Title: COOLTROL RELAY BOX	
Author: BERNIE ALLAIN	
Date: 12-1-2022	Sheet:
Revision: REVISED	Joe Davidson

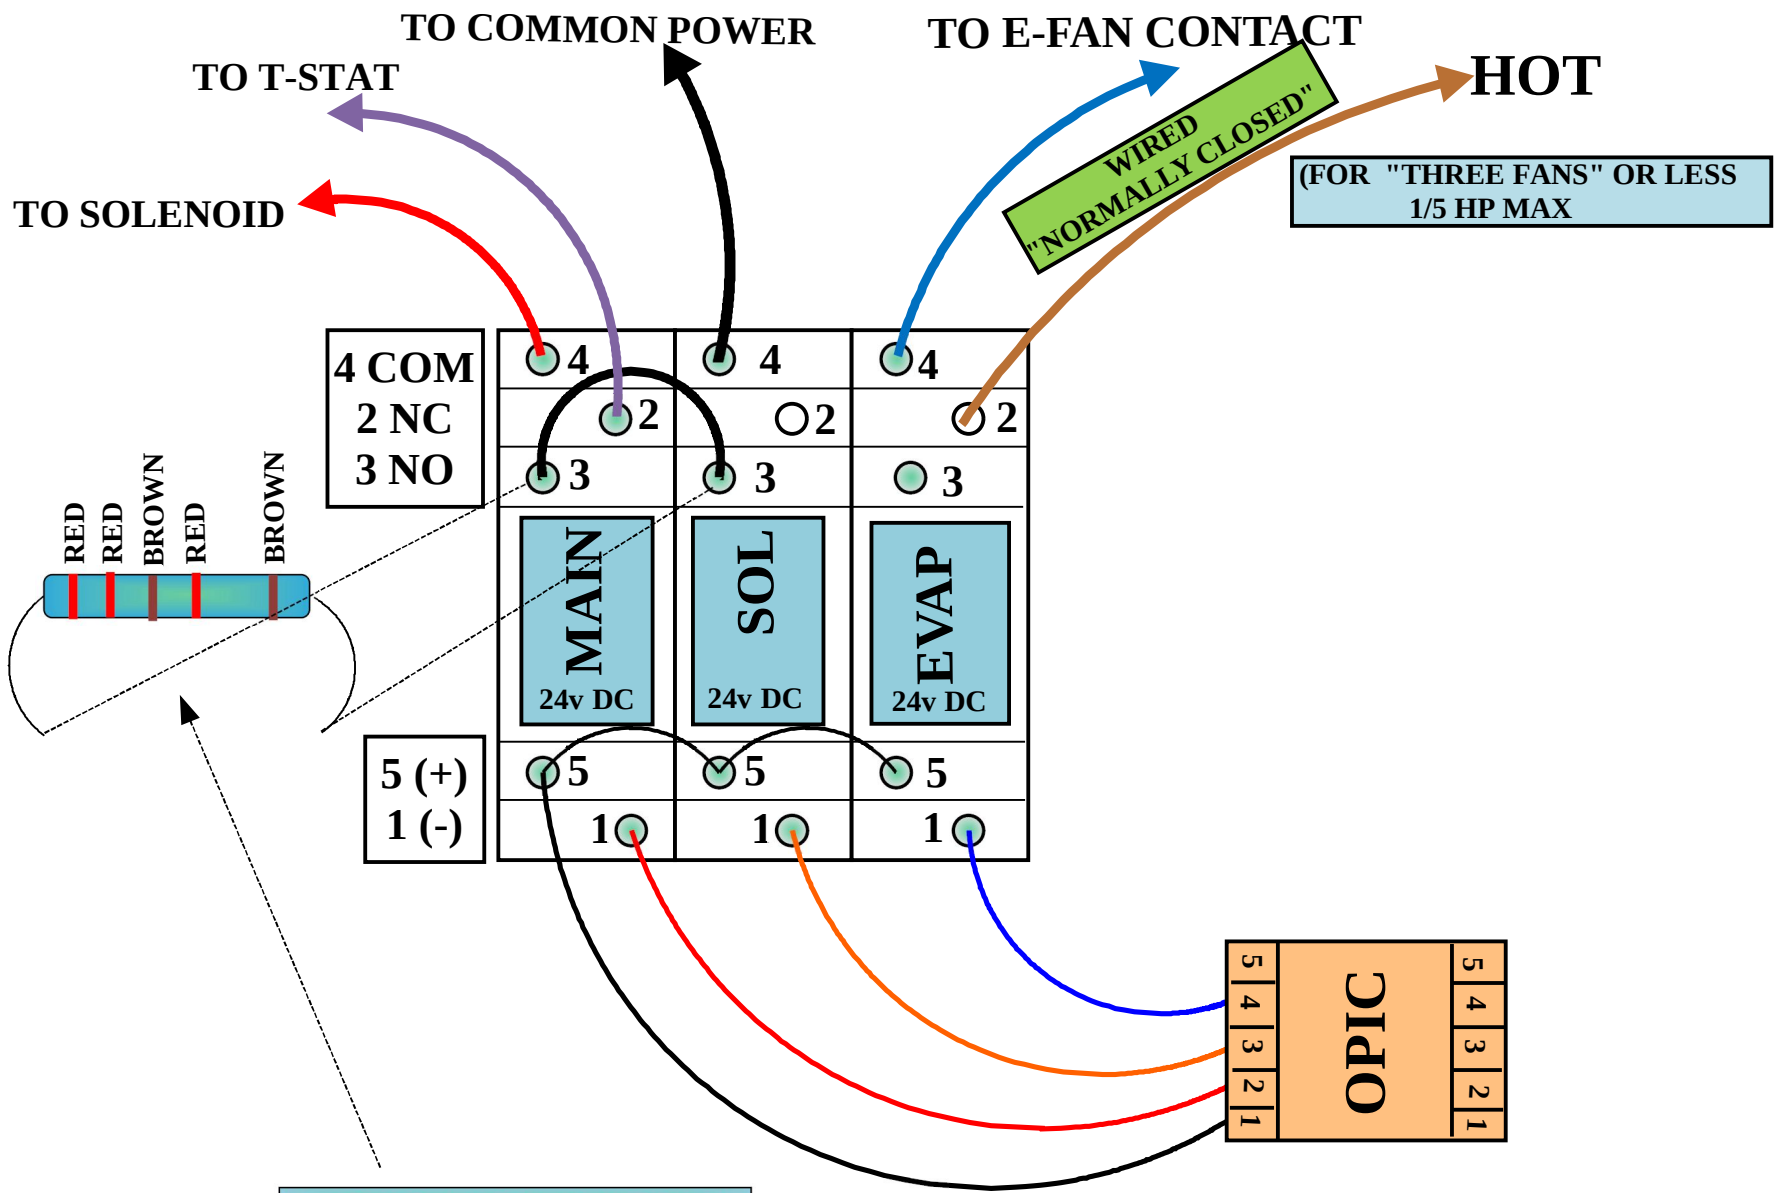
**** IF BEACON SYSTEM****
REPLACE JUMPER FROM MAIN(3) TO SOL(3)
WITH "22.1K RESISTOR"
